September 7th, 2018

Subject: ST3 WSTBE Level 2 preliminary recommendations

ST3 Level 2 Station, Water Crossings,
& Alignment Recommendations

Seattle Center Station

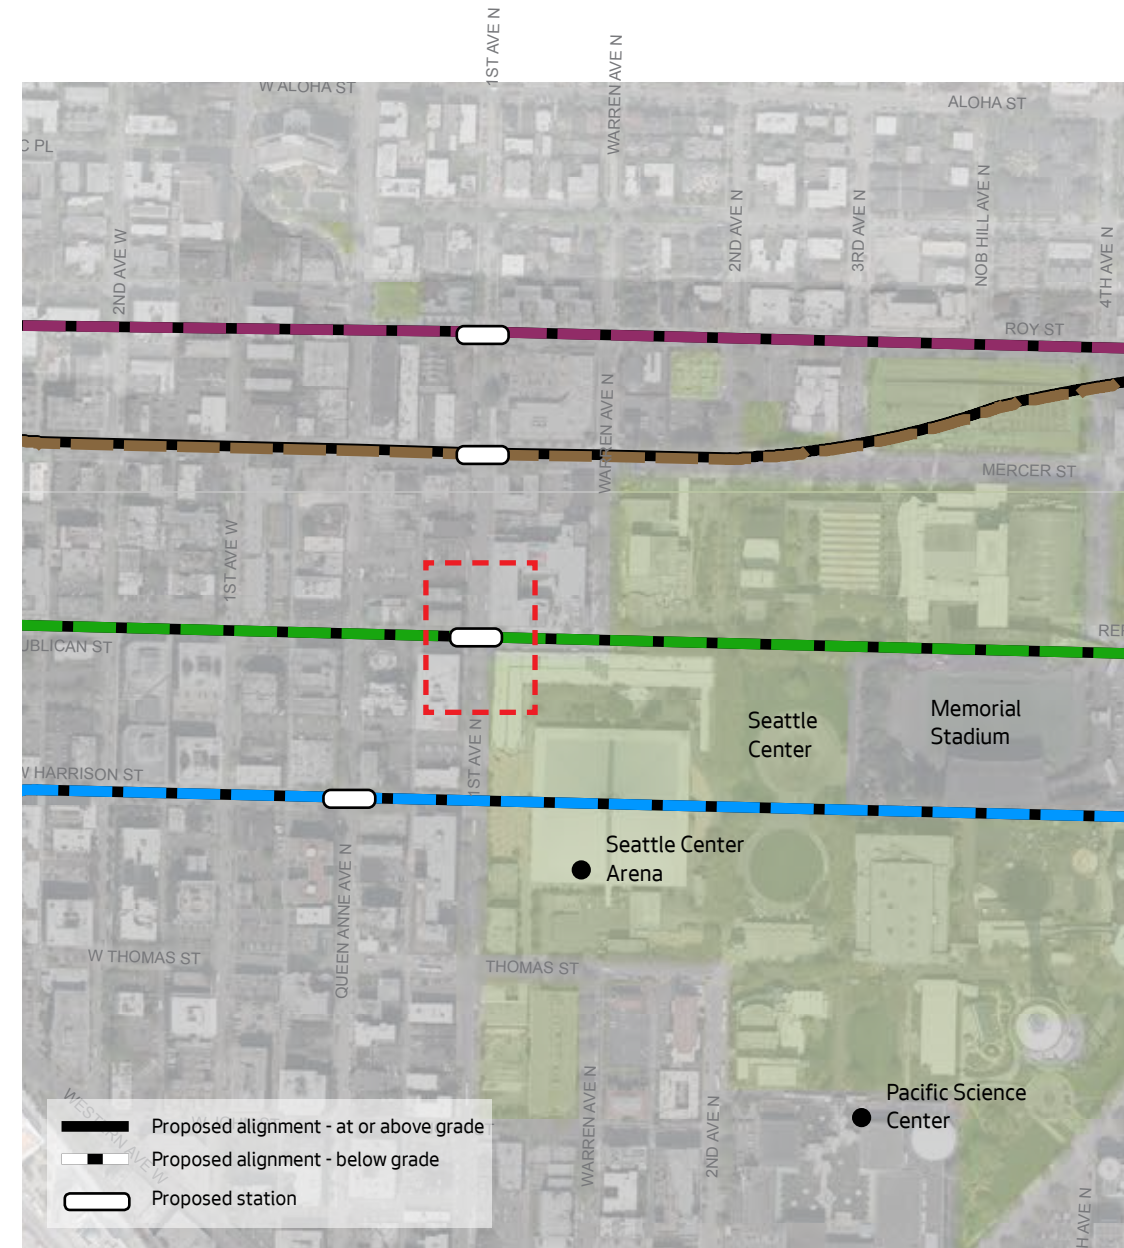
1. Underground at Republican and 1st Ave N
2. Underground at Roy

- Harrison Street alignment would require a deep tunnel that can result in a station location too far from Seattle Center and retail hub

- Consider universal accessibility between the station and the places that people will be trying to reach by light rail. This includes sidewalk grades and street crossings.
- If considering a station at Roy, enhance pedestrian access across Mercer St.
- Do not allow large Seattle Center events to drive the location decision. Consider that an entrance too close to the Arena could pose crowd dispersal problems.

Seattle Center to Smith Cove Line

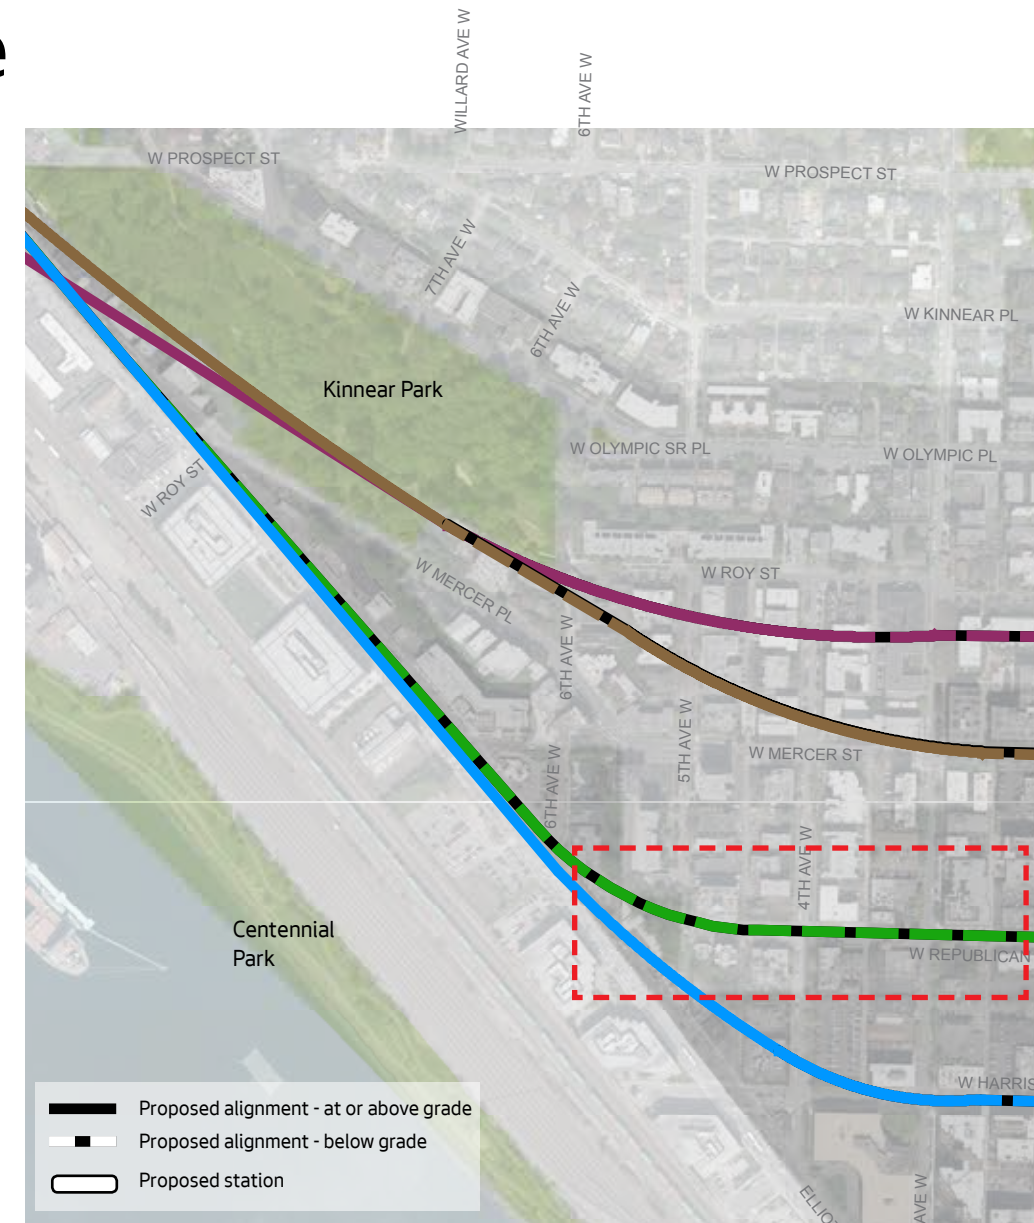
1. Tunnel under Republican and elevated along Elliott
2. All alternatives as needed to connect wherever the Seattle Center Station is located

- Need technical information from Sound Transit to gauge impacts of possible tunnel portal and guideway locations to buildings, park, and traffic

Smith Cove Station

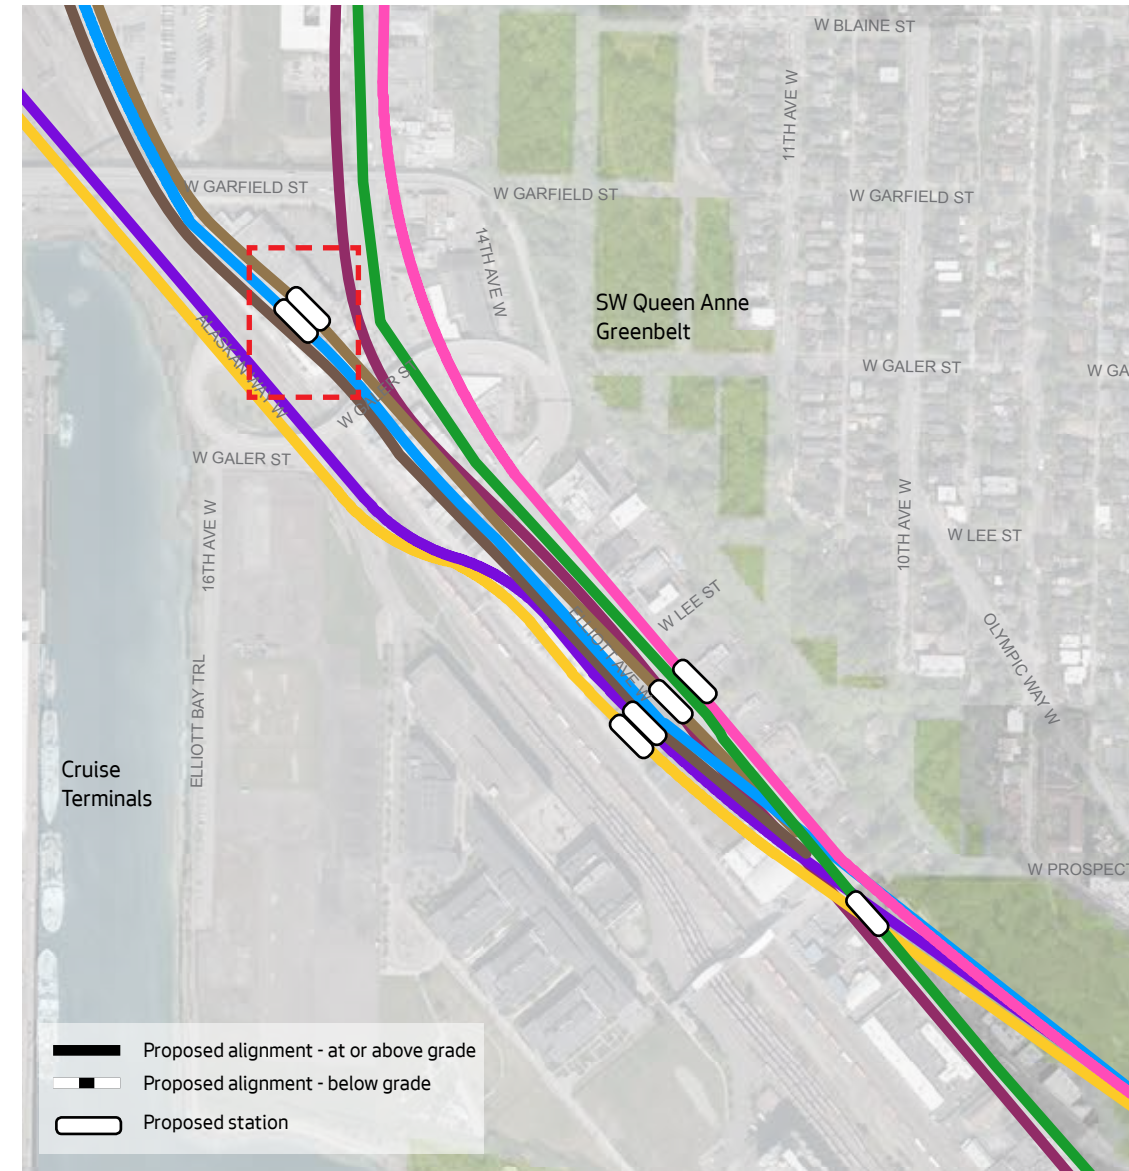
1. At grade at Alaskan Way W and North of W Galer St flyover
2. Above grade at Alaskan Way W and North of W Galer St flyover

- Opportunity to serve growing employment base and expanded tourism facilities
- Opportunities and likelihood of future residential and job density is higher to the north, including possible TOD at the Armory site

- Locate and plan the station to serve the cruise ship terminals
- Connect the station to the bike network
- Improve non-motorized connections from the station to Smith Cove Park and Expedia. Provide maps and diagrams to illustrate how the station connects to these community assets.
- Locate station at grade so that the guideway can cross below the Magnolia Bridge
- Provide cost and visual analysis of alternatives for the line to cross below/above the Magnolia bridge. Include an alternative where the Magnolia bridge is removed.

Smith Cove to Salmon Bay Line

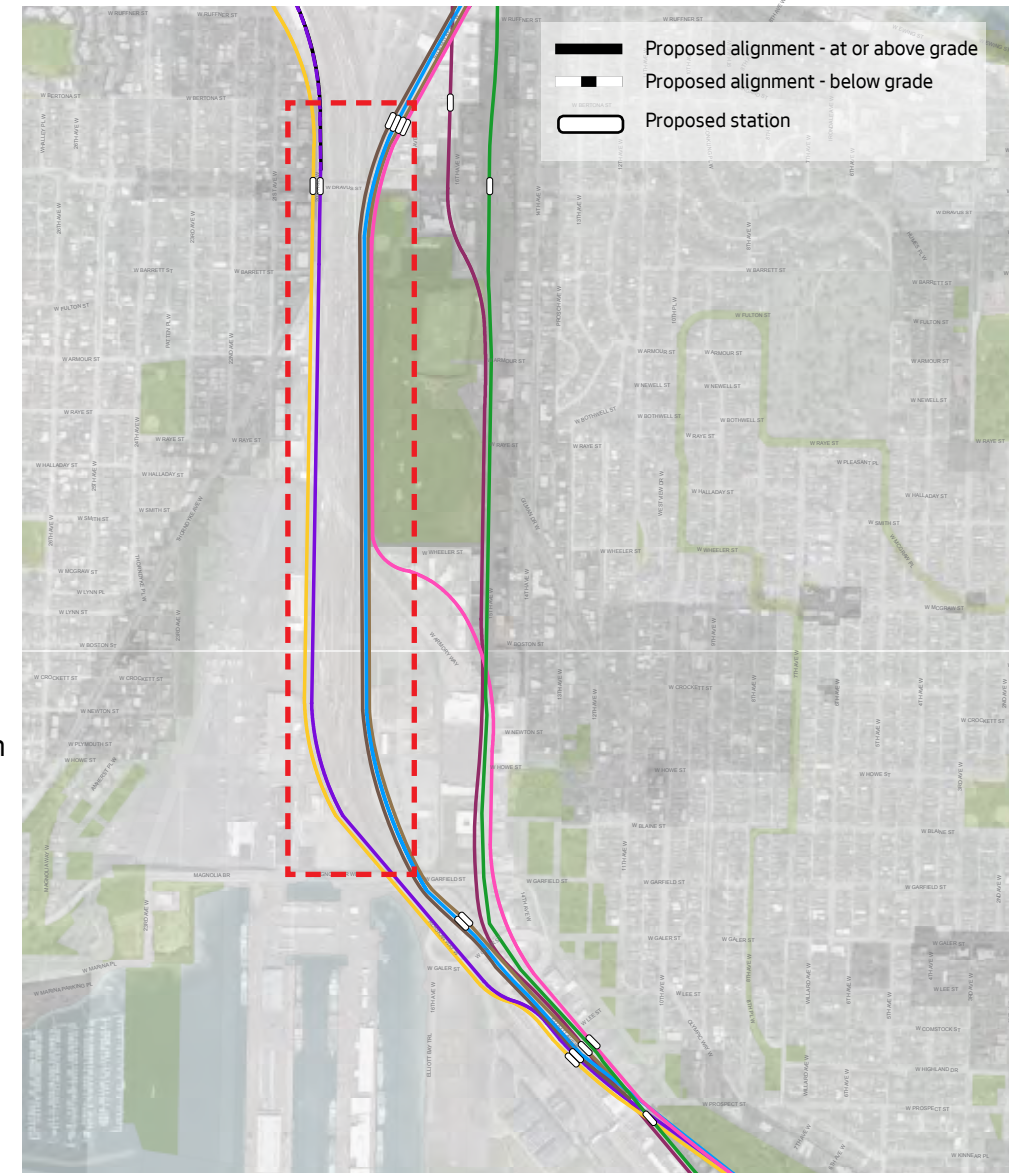
1. At grade, in a trench in or next to the BNSF right-of-way 
2. Elevated along the BNSF right-of-way

- 15th Avenue W option poses too many impacts on transportation network
- Fewer impacts by placing the line in the existing railroad right-of-way where surrounding areas are already impacted by trains

- Study how the alignment will cross Magnolia Bridge
- Study placing the line at grade and/or in a trench along either side of the existing railroad right-of-way in part to reduce costs compared to an elevated guideway
- Provide grade separated crossings for east west cross streets
- Examine the possibility of making this a corridor for cyclists and pedestrians in addition to transit.
- Examine and update City plans for the non-motorized circulation network in this corridor.
- Do not postpone City decisions about the future of the Magnolia bridge because the opportunities and imperatives for both the Smith Cove Station, Dravus Station, and guideways north of the Smith Cove Station are impacted by these decisions.

Dravus Station

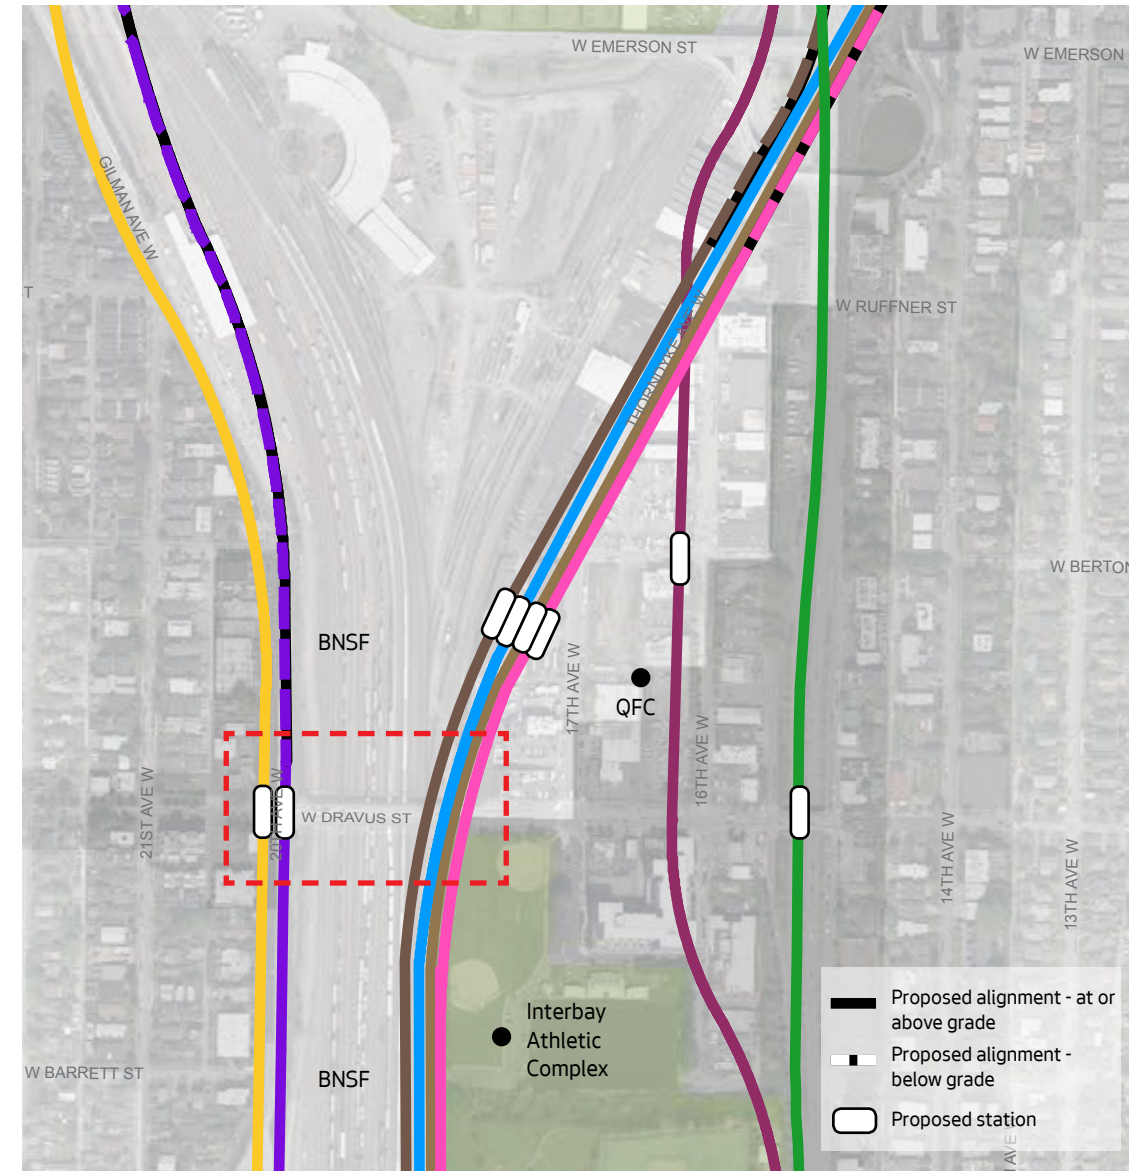
1. On Dravus in the BNSF right-of-way
2. On Dravus between BNSF ROW and 17th Ave W

- Dravus St. provides the best access for all transit modes
- Corridor already includes rail activity

- Study locating the station in the railroad right-of-way in a trench below Dravus St. Explore combining the station with Dravus St. bridge
- Explore replacing the existing Dravus St. Bridge
- Explore possibility of creating multimodal connections on Dravus St.

Dravus to Ballard & Salmon Bay Crossing

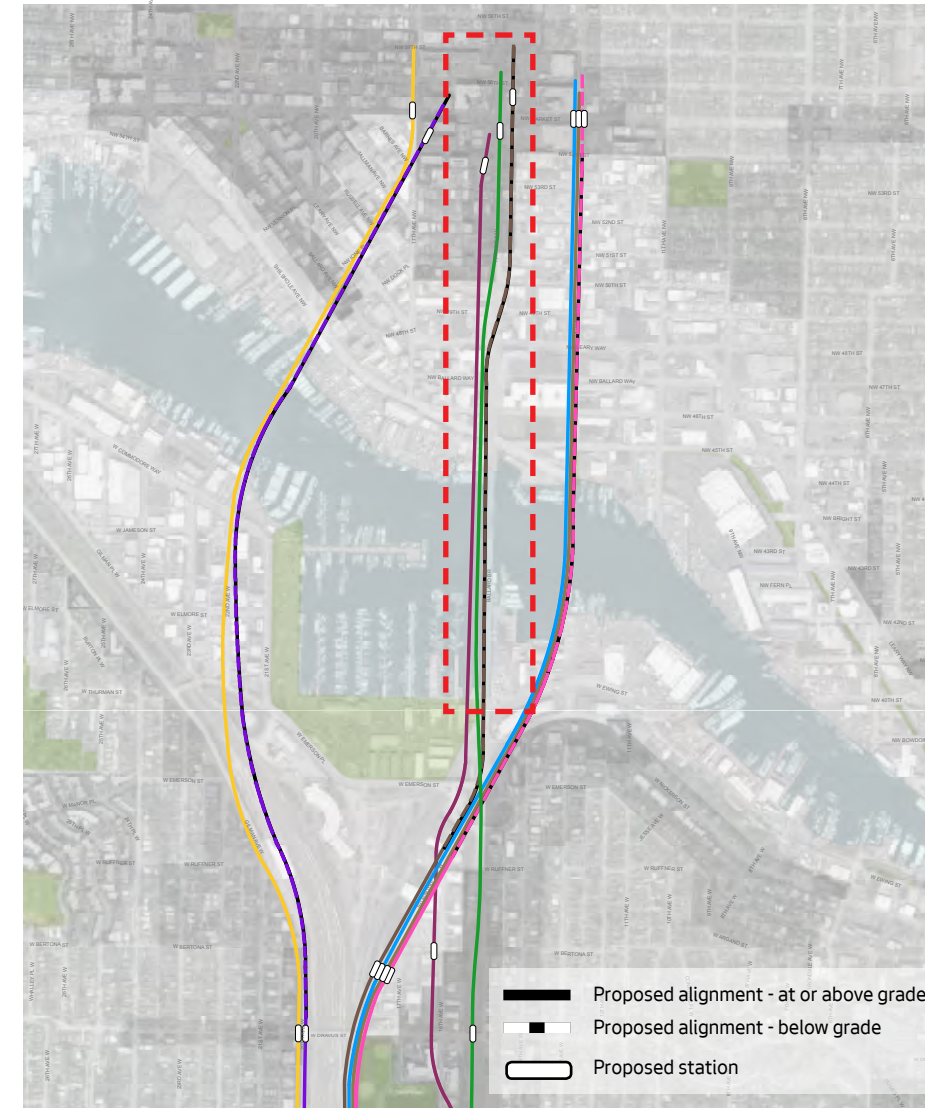
1. Tunnel from Dravus Station to Market & 15th with underground station ■
2. Tunnel from Dravus Station to Market & 17th with underground station ■
3. Elevated line from Dravus to 15th & 54th or 56th with a new, multi-modal, fixed bridge in the current Ballard Bridge alignment and station above or at grade (new bridge carries current Ballard Bridge traffic, light rail, and non-motorized modes) ■

- A movable bridge is the least desirable alternative because of impacts to traffic and vulnerability to system disruption
- 15th and Market Street provides the best location for future system expansion
- A tunnel in historic Ballard generally eliminates impacts on historic resources and neighborhood character

- To maximize efficiency, control construction costs and reduce neighborhood impacts, Sound Transit and the City should explore the idea of replacing the Ballard Bridge with a new bridge that provides room for transit, autos and non-motorized
- Any bridge type in any location should provide multimodal transit and non-motorized facilities. The City should partner with Sound Transit in fully examining this idea.
- Any bridge type in any location should be complimentary to its surroundings and sensitive to its natural, cultural, and built context
- In the 15th Ave corridor, in a fixed or movable bridge scenario, study options for alignment that result in an at-grade station at Market
- If a movable bridge is pursued provide the most technically advanced bridge to avoid service disruption
- If a fixed bridge is pursued consider visual impacts where bridge aligns in Ballard
